12 May 2025 Job No: 1015172.1701

s92 Further Information Request - Response Document May Road Stream Enhancement (BUN60444050)

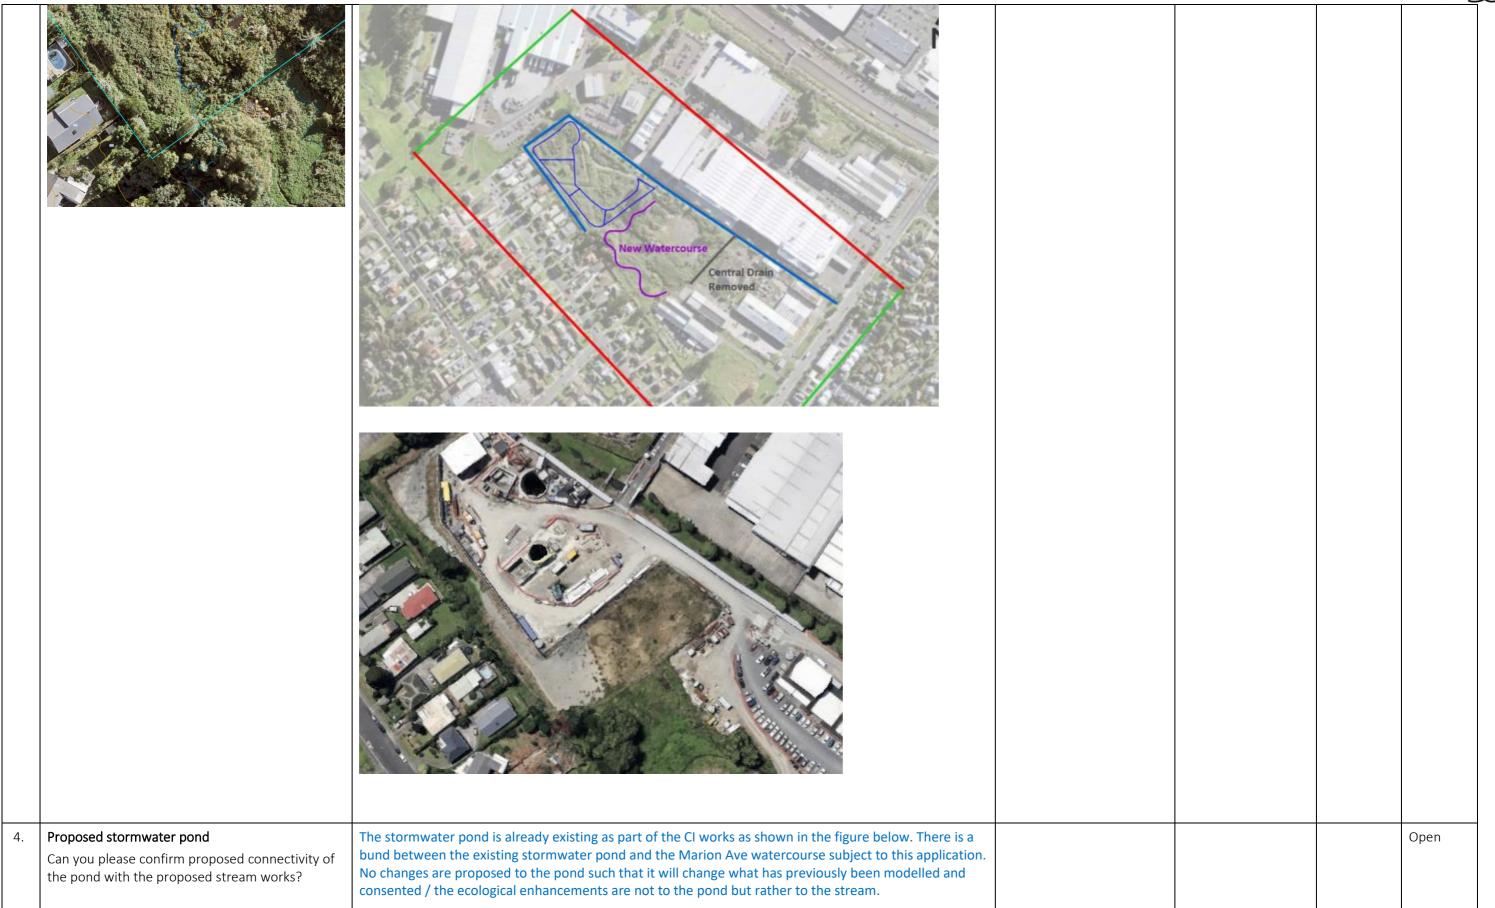
2. The submitted cross sections of the stream channelling do not appear to show all of the proposed finished ground levels. Please update the cross sections to include all finished ground level profiles as they relate to the proposed earthworks.

As set out above, the remainder of the site beyond the stream reprofiling has been modified – see Figure above. The finished ground levels provided in the cross sections show the change in stream profile subject to this application which will then be tied into the existing ground profile as a result of the consented/designated CI works (outside the scope of this application).
